SUBJECT: Forwards application for amends to Licenses NPF-14 & NPF-22  
 re App R ESW mods.

SUSQUEHANNA STEAM ELECTRIC STATION  
PROPOSED AMENDMENT 123 TO LICENSE NO.  
NPF-14 AND PROPOSED AMENDMENT 70 TO  
LICENSE NO. NPF-22:  
APPENDIX R ESW MODIFICATIONS  
PLA-3180                      FILES A17-2/R41-2

NOTE: THIS SIMPLIFIED DIAGRAM OF THE RR/SV/ESV SYSTEMS SHOWS FLOW PATHS, BUT DOES NOT PRESENT BRANCHES IN THEIR PHYSICAL ORDER.

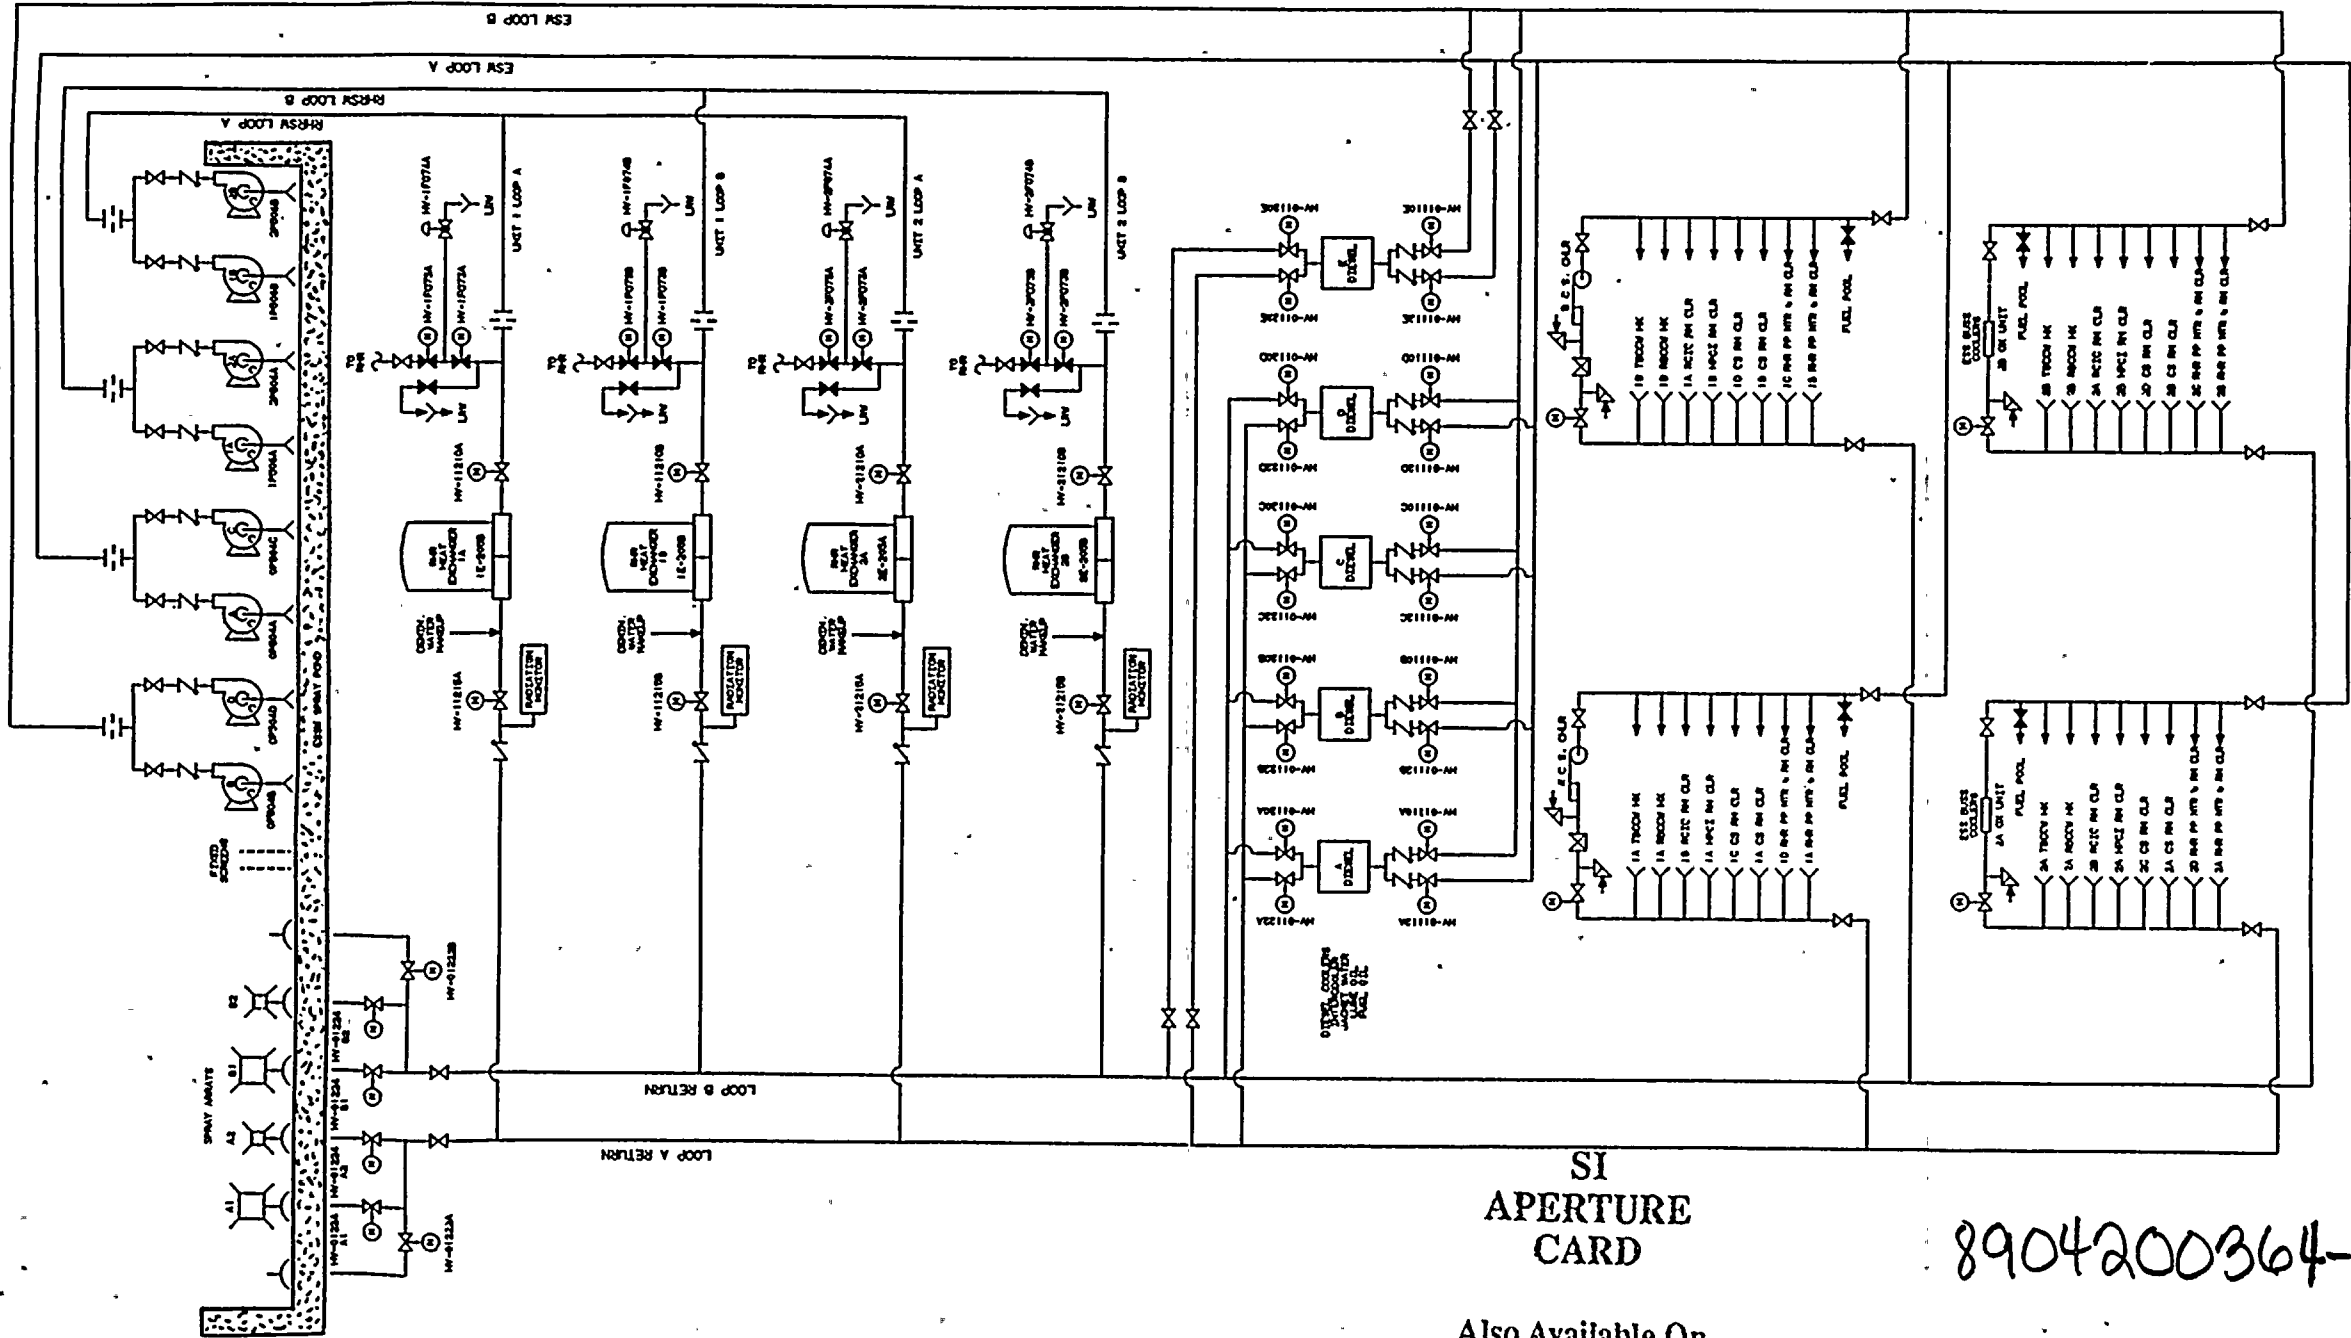
The proposed action is to modify the controls of the ESW valves for the Emergency Diesel coolers as follows:

1. The valve controls on Main Control Room Panel OC653 are removed. The valve position indicating lights are not removed so that the control room operator has valve position status for the aligned diesel generators. A fire in the control room can result in shorting the indicating lights which blows the control power fuse, but the valves will not change position once the modification is complete.

2. Local valve controls are added to the Engine Control Panel OC521 in Diesel Generators A through D bays and the Building Auxiliary Services Panel OC577E in the Diesel Generator E building. The local controls are used to close the ESW valves to isolate the diesel generator during maintenance and to open the valves when the diesel generator is aligned.

3. The auto-loop transfer logic is removed and both loops of the ESW System are normally aligned to the coolers of the four diesel generators in service.

4. Auto-closure logic is added to the Loop A valves of Diesel Generator E. The logic is the same as the existing Loop B logic which closes the valves and trips the output breaker if a LOOP and/or LOCA occur when the Diesel Generator E is not aligned but is being tested.

5. The continuous bypass of the thermal overload protection for the aligned diesel generators is deleted. Automatic bypass of the thermal overload protection is added to the Loop A ESW valves for Diesel Generator E when it is not aligned and is being tested.
